CITY OF THE COLONY, TEXAS

ORDINANCE NO. 2014 -2048

**2012 INTERNATIONAL RESIDENTIAL CODE
WITH LOCAL AMENDMENTS**

****Figure R602.6.1; delete the figure and insert the following figure:**

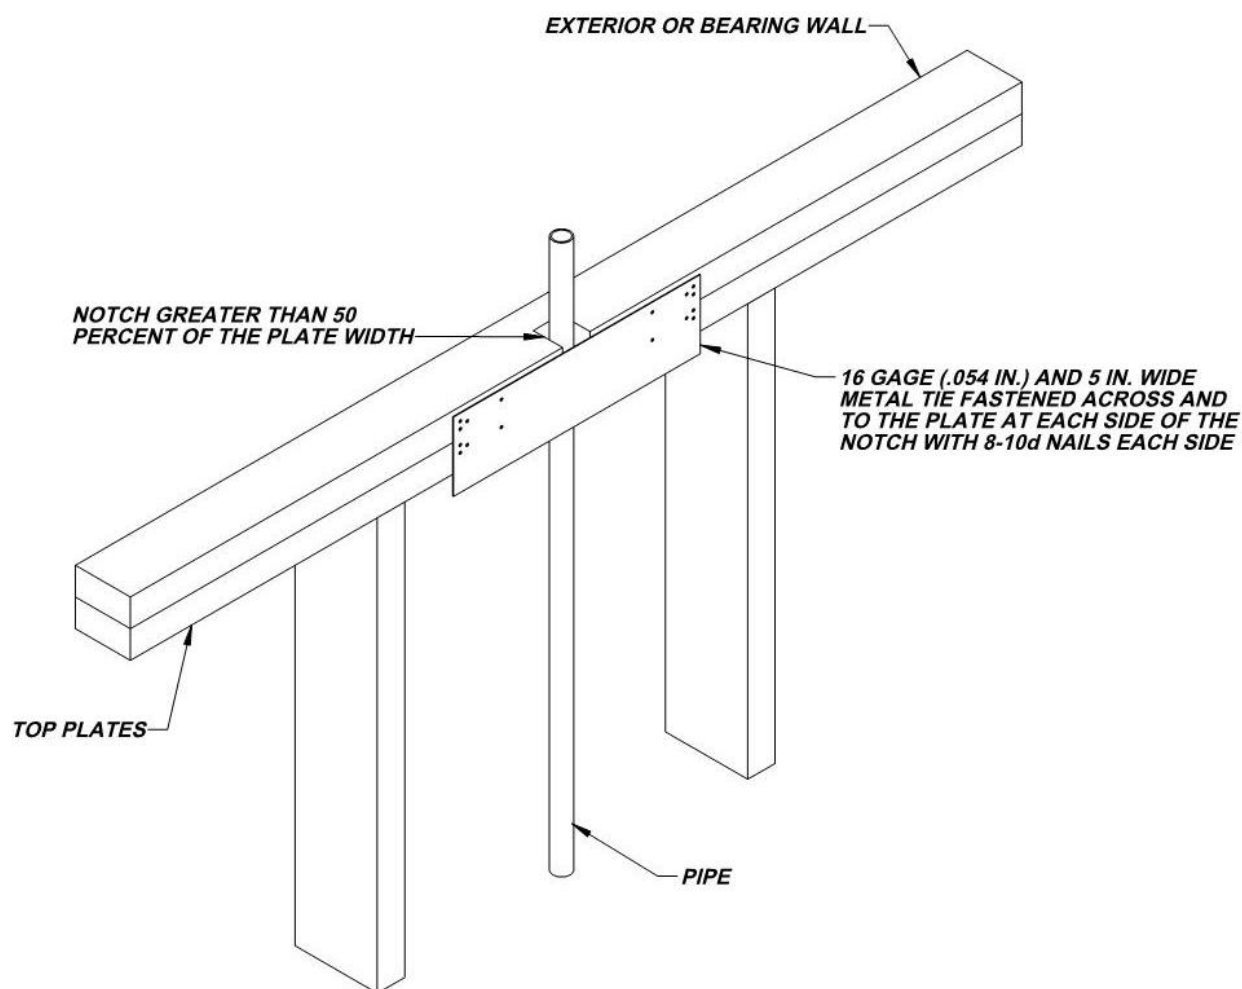
R602.6.1 Drilling and notching of top plate. When piping or ductwork is placed in or partly in an exterior wall or interior load-bearing wall, necessitating cutting, drilling or notching of the top plate by more than 50 percent of its width, a galvanized metal tie not less than 0.054 inch thick (1.37 mm) (16 Ga) and 5 inches (127 mm) wide shall be fastened across and to the plate at each side of the opening with not less than eight 10d (0.148 inch diameter) having a minimum length of 1 ½ inches (38 mm) at each side or equivalent. Fasteners will be offset to prevent splitting of the top plate material. The metal tie must extend a minimum of 6 inches past the opening. See figure R602.6.1. *{remainder unchanged}*
